NUMBER: B402R1102-0

## SERVICE BULLETIN

Ride: WIPEOUT

Subject: Boom Limit Switch

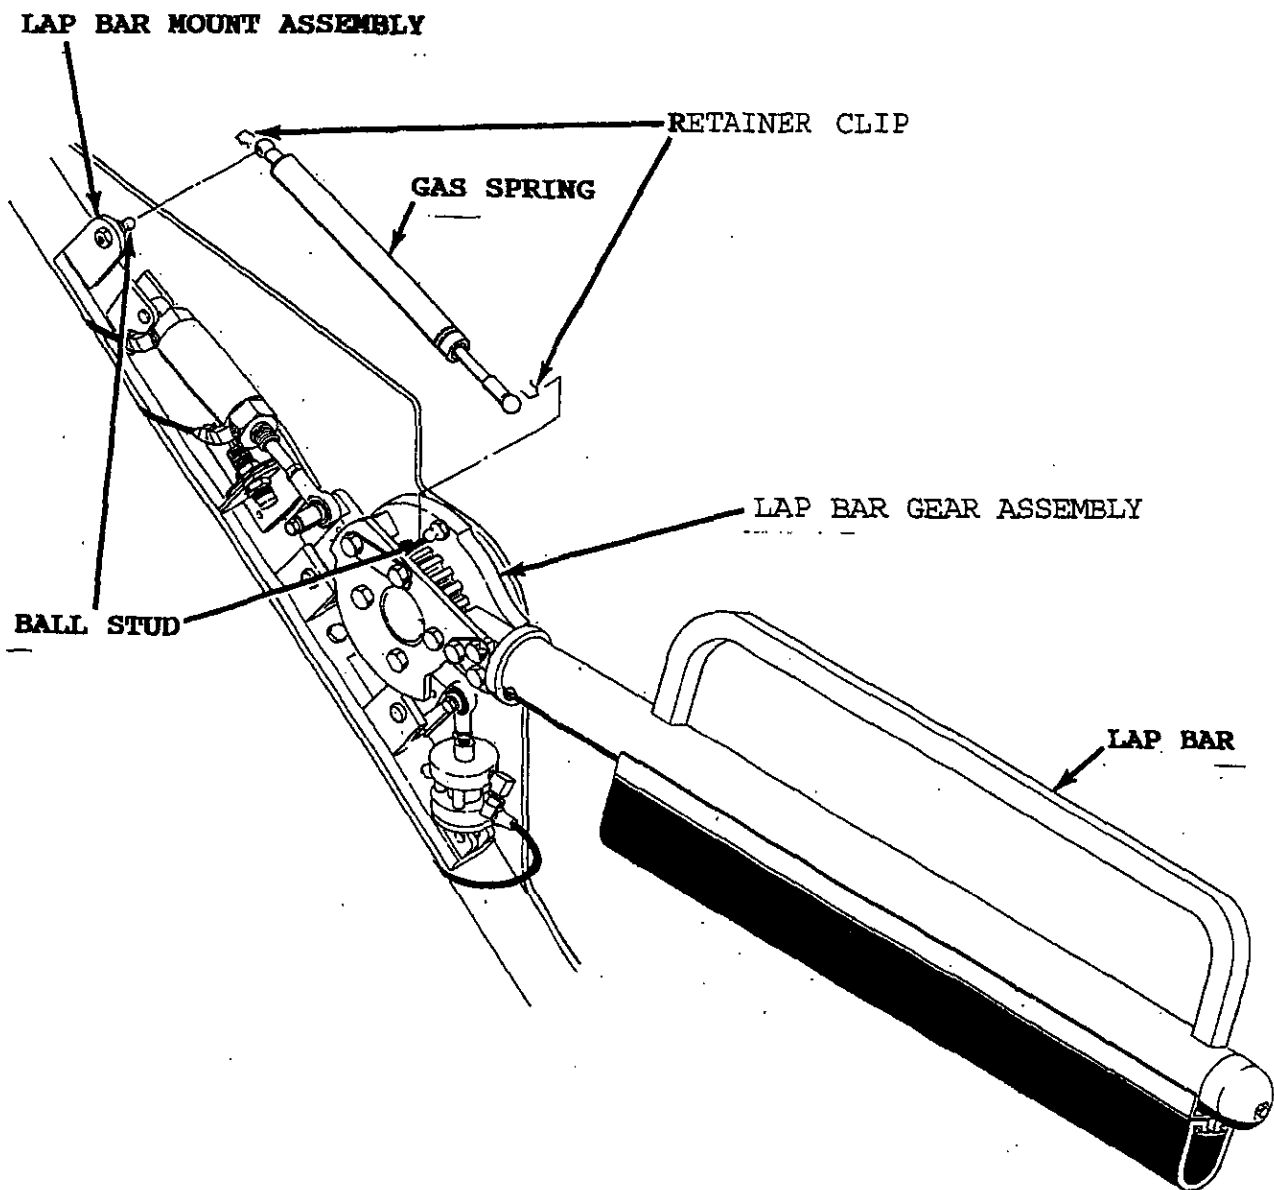
Subject: Ball Stud Recall

Chance Rides, Inc. has become aware that some parts not adequate for their intended use were received and possibly used on some WIPEOUT amusement rides. These parts are the ball studs holding the gas springs in place on the lap bars. If a ball stud breaks the lap bar can fall to the closed position, causing possible injury to passengers.

Install the 40 ball studs, 2 per lap bar, part number 27536300 as shown in this bulletin. To receive credit for ball studs shipped with this bulletin return the completed Certification Of Compliance and the old ball studs within fifteen (15) days from receipt of bulletin.

Ball Stud Replacement Procedures:

1. Access lap bar locking mechanism by removing countertop panel.
2. Remove retainer clip from each end of gas spring.
3. Remove the gas spring from the ball studs.
4. Unscrew one ball stud from the lap bar gear assembly and one from the lap bar mount assembly.
5. Using the new ball studs, reverse the above procedure.

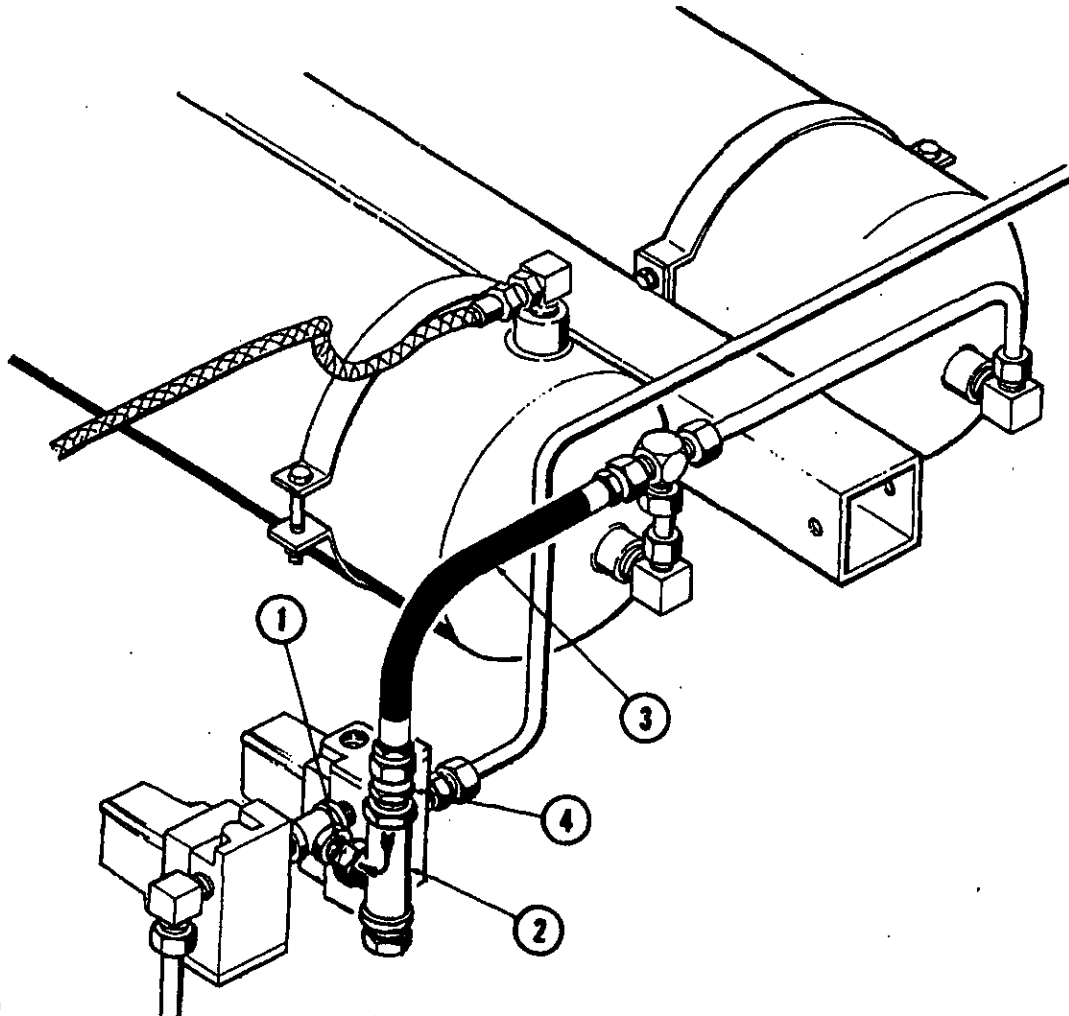
Subject: Air Filter Kit Rework

Chance Rides, Inc. has become aware that foreign material in the air system may become entrapped in the directional control valves of the brake system on the WIPEOUT amusement ride. If this occurs, damage to the valves may result, making the replacement of the valves necessary. Chance Rides, Inc. has developed a filter kit to help reduce the possibility of this damage occurring.

All owner/operators of the above noted WIPEOUT rides are required to order and install Kit #K402R1107-0. Perform the rework using the instructions provided with this bulletin. Return the attached Certification Of Compliance within fifteen (15) days from receipt of kit.

## KIT INSTALLATION INSTRUCTIONS

1. Locate and remove the 1/2" hard line that connects the air tanks to the directional control valves, as shown in illustration A.
2. Remove the 1/2" to 1/4" adapter from the 1/4" tee, as shown in Illustration A.

3. Install 1/4" close nipple (Item 1) to the 1/4" tee, as shown in Illustration B.
4. Install air filter (Item 2) into close nipple (Item 1) with thread connection pointing upwards.
5. Install 1/4" to 1/2" adapter (Item 4) into end of filter (Item 2).
6. Connect adapter (Item 4) to the air tanks with air hose (Item 3).

ILLUSTRATION A

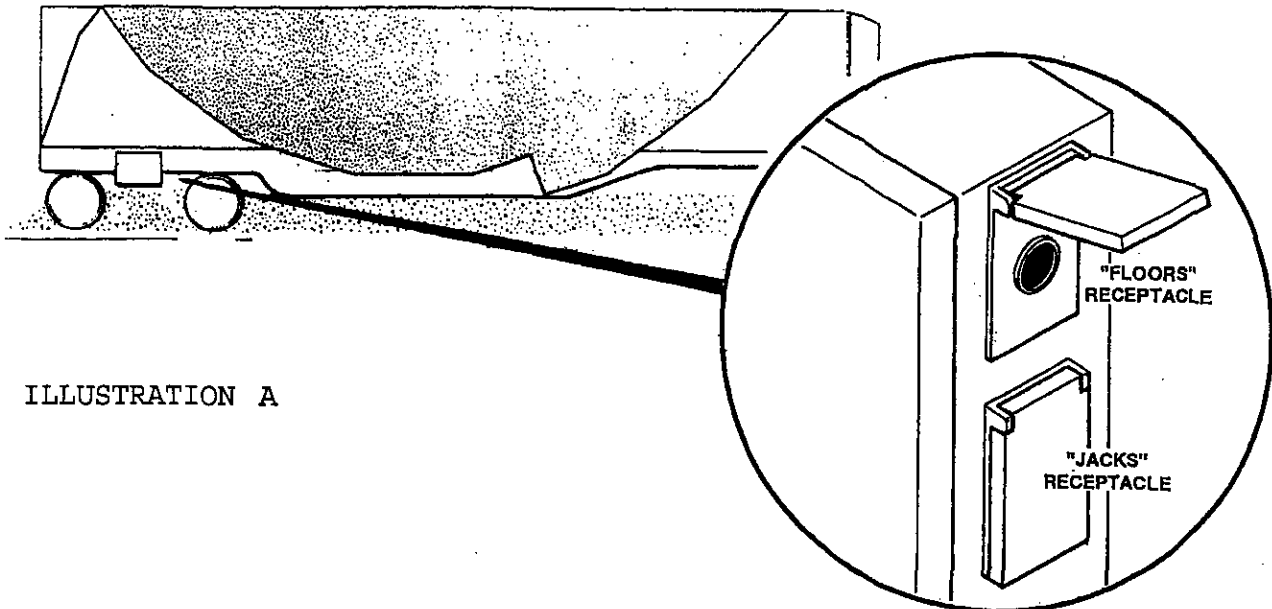
The hydraulic cylinders for lowering the side floors are operated by the hand-held control box which installs into the receptacle labeled "floors". The receptacle is located on the curbside electrical box, just forward of the rear jack (see Illustration A).

NOTE: Care must be taken to assure the hand-held box is installed into the proper receptacle at the proper time. The inability to do this may result in damage to the floor cylinder turn buckle assemblies.

ILLUSTRATION B

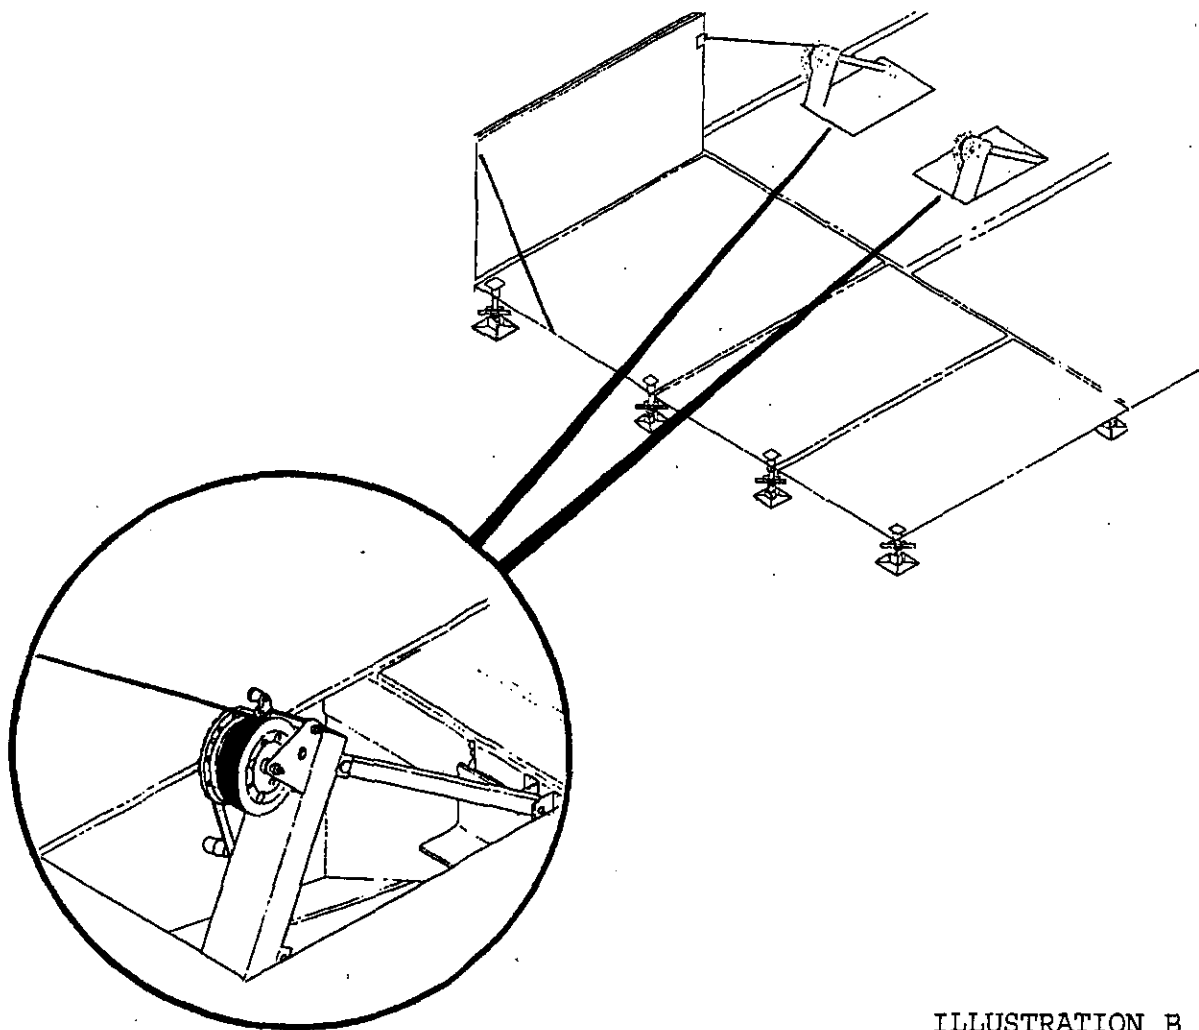
Two winches are used to lower the front floor section. These winches are located under floor access panels in front of the operator's control house (see Illustration B). Once the front floor section has been lowered, the winches must be stowed and the access panels reinstalled.

**WARNING:** DO NOT ATTEMPT TO LOWER FLOORS WITHOUT THE USE OF THE WINCHES OR CYLINDERS. FAILURE TO COMPLY WITH THIS BULLETIN COULD RESULT IN INJURY.

## INSPECTION/REPLACEMENT OF PUMP MOTOR HEATERS

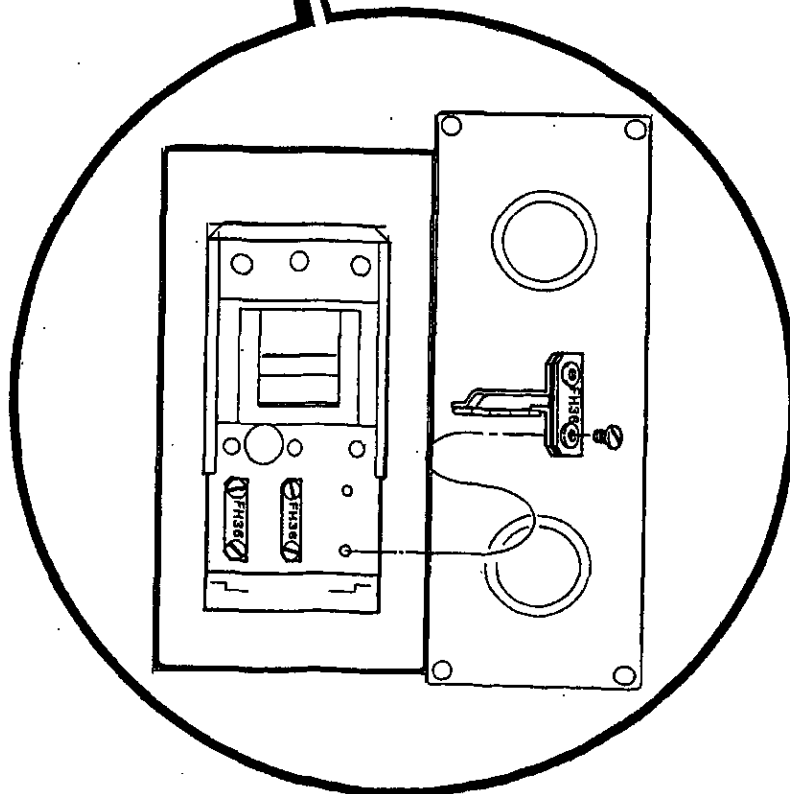
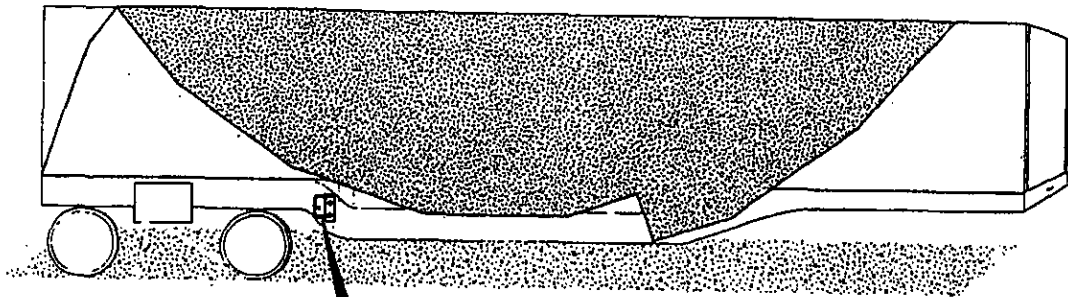
Chance Rides, Inc. has become aware that incorrectly sized overload protectors, heaters and fuses, may have been installed on the above noted WIPEOUT amusement rides. The correct size heaters and fuses are necessary to prevent damage to the oil cooler motor, the pump motor for the leveling jacks, and the motor for the air compressor.

Three heaters are located in box between rear leveling jack and the floor/jack receptacle box, located on the curbside of the trailer.

1. Remove cover from box by removing the one screw located at the bottom of the box.
2. Heaters are labeled as to size. Correct size is FH36. If any other size heater is present, order and install new heaters, part number 23324700.
3. To replace heaters, remove the two (2) screws securing the heater in place.
4. Reinstall cover after work is completed.

INSPECTION/REPLACEMENT OF OIL COOLER MOTOR HEATER & AIR COMPRESSOR FUSE

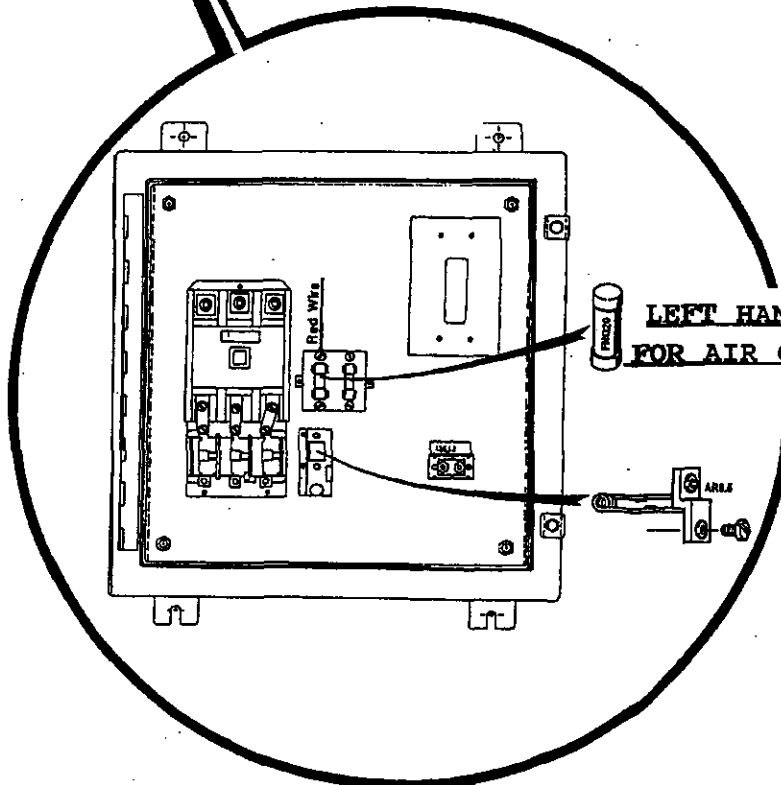
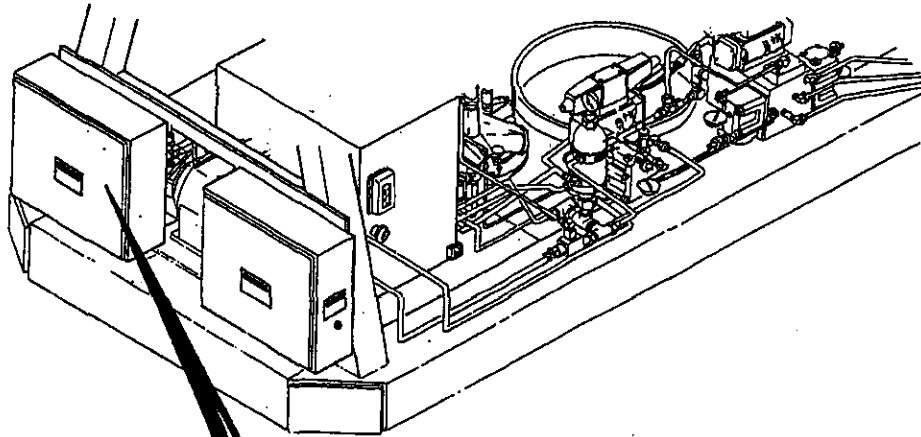
This heater and fuse are located in the motor control box, the left hand box with the on/off handle, mounted to the turret.

LEFT HAND FUSE ONLY IS  
FOR AIR COMPRESSOR MOTOR

1. Turn power handle to off position and open door.
2. Locate single heater and inspect for correct heater size. Correct size is AR8.5. If any other size heater is present, order and install new heater, part number 23331702.
3. To replace heater, remove the two (2) screws securing the heater in place.
4. Locate fuse in fuse block directly above oil cooler motor heater and inspect for proper size. The fuse may have to be removed to determine size. The correct size is FNQ20. If any other fuse is present, order and install new fuse, part number 22149200.

Subject: Hub Capscrew Torque Check

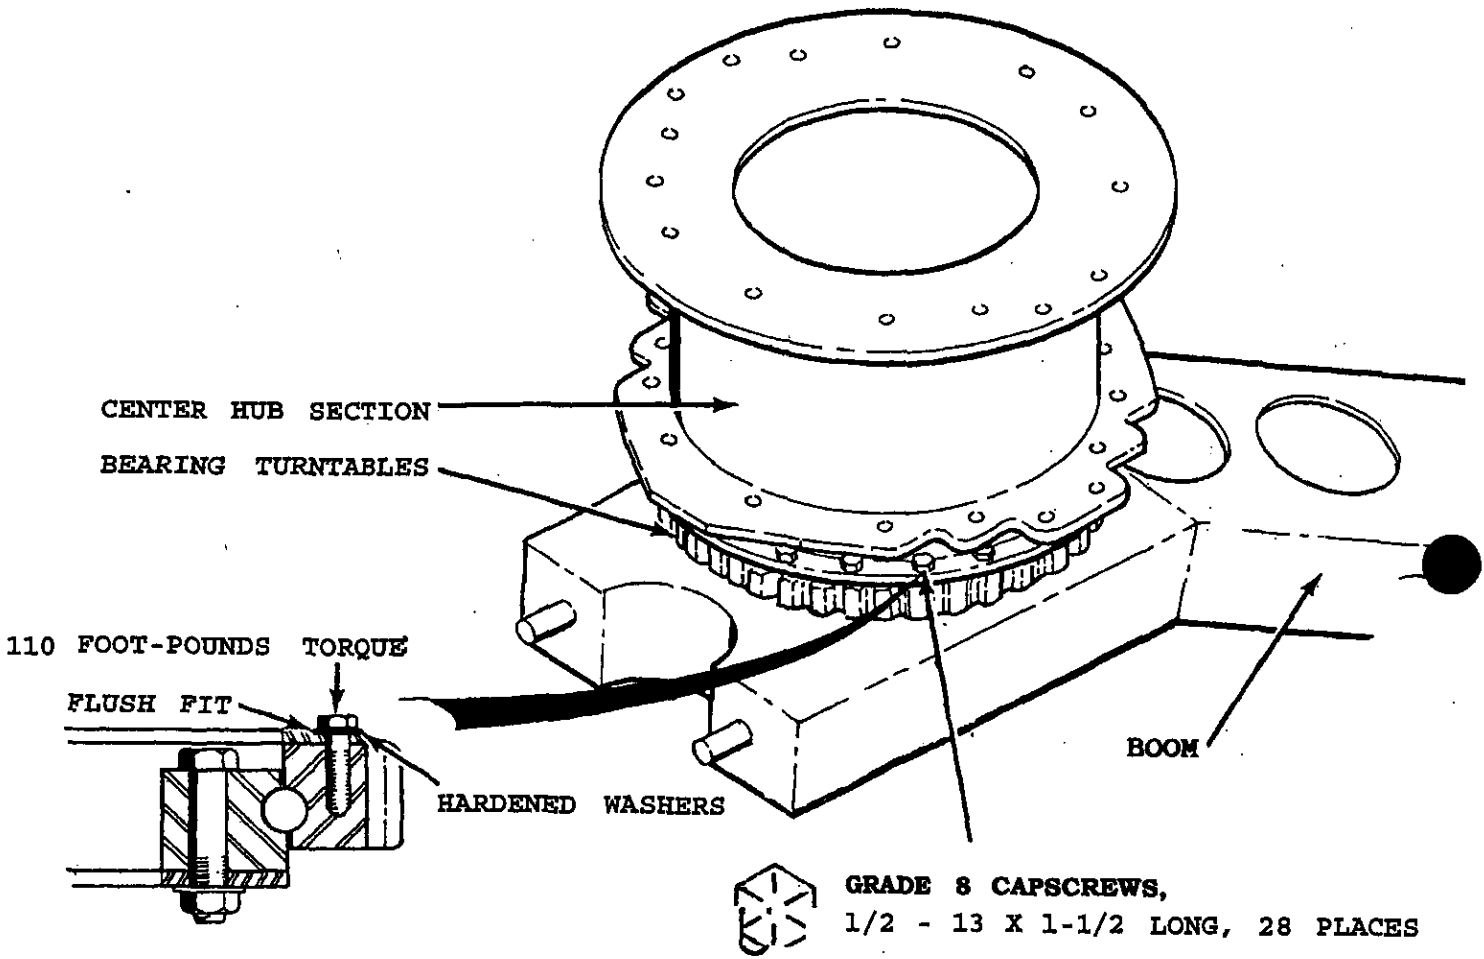
The Center hub section on the WIPEOUT amusement ride is secured to the bearing turntable on the boom by 28, Grade 8 hex-head capscrews. It is essential for the care of the equipment and safety of the passengers to maintain the proper torque on these capscrews. Chance Rides, Inc. requires all owner/operators of the above noted rides to perform the following check at least once per month during the operating season.

1. Verify that the 28 hardened washers under the capscrews securing the center hub section to the bearing turntable on the boom fit flush to the hub.
2. Using a torque wrench, check for proper torque of these 28 capscrews. Torque values for these capscrews should be 110 foot-pounds.

NOTE: If capscrews are removed and reinstalled with lubricated threads 90 foot-pounds must be maintained.

Subject: Strobe Light Rework

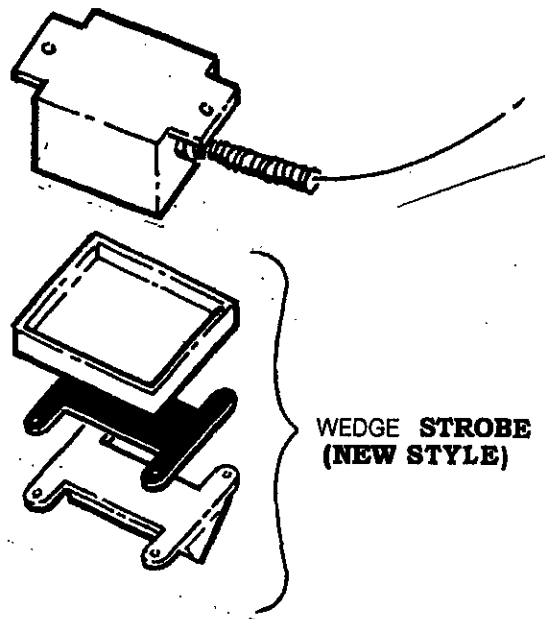
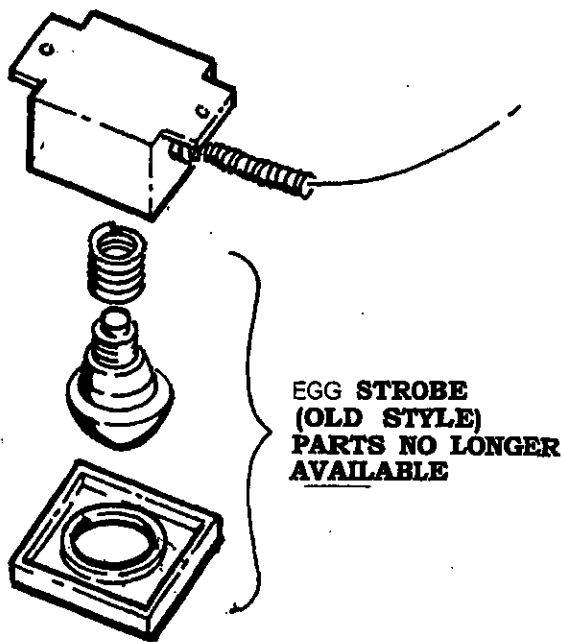
Chance Rides, Inc. has improved the design of the strobe lights on the WIPEOUT amusement ride. These strobe lights are located on the underneath side of each sweep. Owners of the above noted rides can replace the original style strobe lights by ordering and installing kit number K402R1112-0. Each kit contains all parts and instructions necessary to rework one ride. Kits will be supplied at no charge, if ordered within 90 days of the date on this Product Improvement Notice.

<u>Part Number</u>	<u>Description</u>	<u>Qty</u>
28093400	Transformer	1
61115200	8-32 x 1/2 Machine Screw	4
64780400	8-32 Lock Nut	4
24082600	Strobe Light with Gasket	20
71110300	Cover	20
10000400	Yellow Twist Cap	41
K402R112-0	Drawing	1
